# UNITED STATES PATENT AND TRADEMARK OFFICE

APPLICATION NO.	FILING DATE	FIRST NAMED INVENTOR	ATTORNEY DOCKET NO.	CONFIRMATION NO.
09/704,028	11/01/2000	Gary G. Lenihan	060545/0456	2436

# Office Action Summary

## DETAILED ACTION

Fig  
(9)

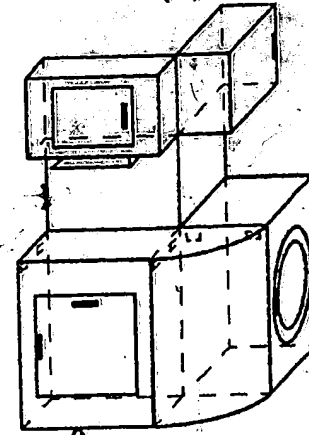
Klien teaches in figures 1-8 a toy kitchen comprising a main unit (marked copy fig.9) and a repositionable island (marked copy fig. 9) removably coupled to a front surface of the main unit (marked copy fig. 11) to form at least two separate play areas (marked copy fig. 11).

Regarding claim 2, as best understood, Klien further teaches removably attached to the main unit in one of at least three positions (fig. 9 and fig. 11).

Regarding claim 17, Klien further teaches the first unit removably positioned to the second the second unit in at least the first and second positions (fig 9 and 11).

Fig  
(10)

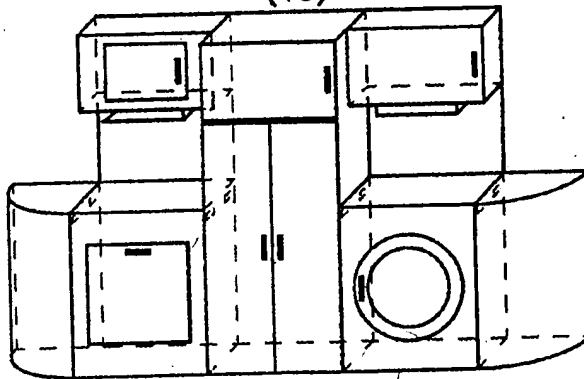
McKee teaches in figures 1-13 a toy kitchen comprising a main unit (marked copy fig. 10) and a repositionable island (marked copy fig. 10) removably coupled to a front surface of the main unit (marked copy fig. 10) to form at least two separate play areas (marked copy fig. 10).

Regarding claim 9, as best as understood, McKee further teaches a front and rear side (fig. 10), an opening defined within the main unit extending from the front side to the rear side (marked copy fig. 10) and the main unit comprising a window at the opening (marked copy fig. 10).

Fig  
(11)

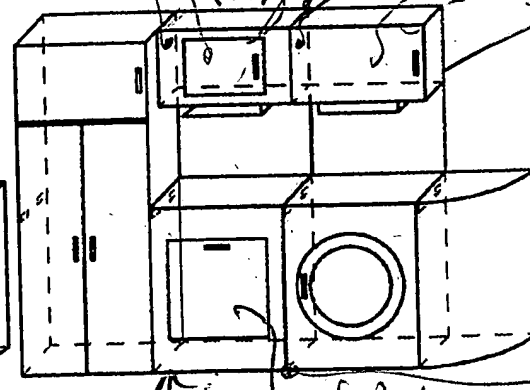
Regarding claim 6, Klien further teaches the island is removably connected to the left side of the main unit (fig. 11) to form a continuous play area along a single plane.

Regarding claim 12, Klien teaches in figures 1-8 a repositionable toy kitchen comprising a first unit extending along a first vertical longitudinal plane (marked copy fig. 11), at least one removable and repositionable second unit extending along a second vertical longitudinal plane (marked copy fig. 11), the second unit removably connected to a front surface of the first unit to form at least two play areas (marked copy fig. 11, "play area") and the second position, where the first and second planes are coplanar (fig. 11).

Regarding claim 13, as best understood, Klien further teaches first and second play areas (marked copy fig. 11 "first and second play areas"; notice the examiner considers the space indicated by "second play area" behind the first unit and the space

indicated by "first play area" to be the play areas), the first and second play areas bounded by the one side of the first unit (As best understood, the examiner considers the first and second areas to be bounded by the sides where the first and second unit meet as seen in marked copy fig. 11, "bounded"), and the second position defines a continuous play area extending along of the second unit (fig.11).
